RIELLO INFORMS YOU

RIY_13

Product update

New release of RMG-RMO control box, now named CMG-CMO

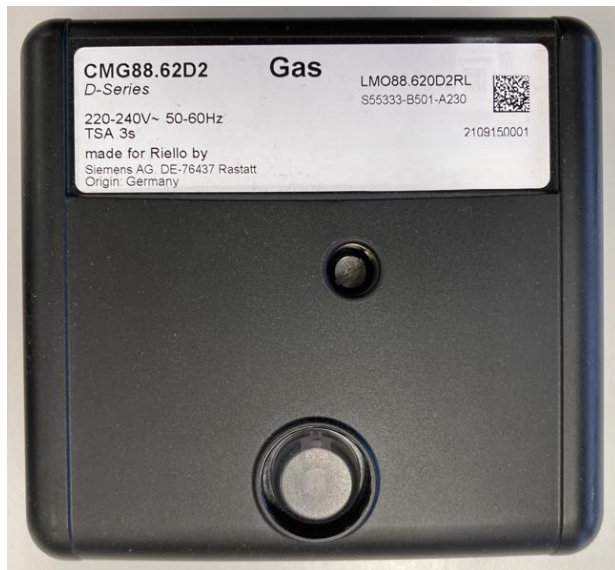
The below pictures show the RMG control box compared with the CMG; from the comparison it's possible to recognize the differences which are the name, CMG instead of RMG, and the control-box series, D-series instead of C-series.

The new CMG-CMO replace the previous RMG-RMO and the two are identical as performance, layout and dimensions, so completely interchangeable.
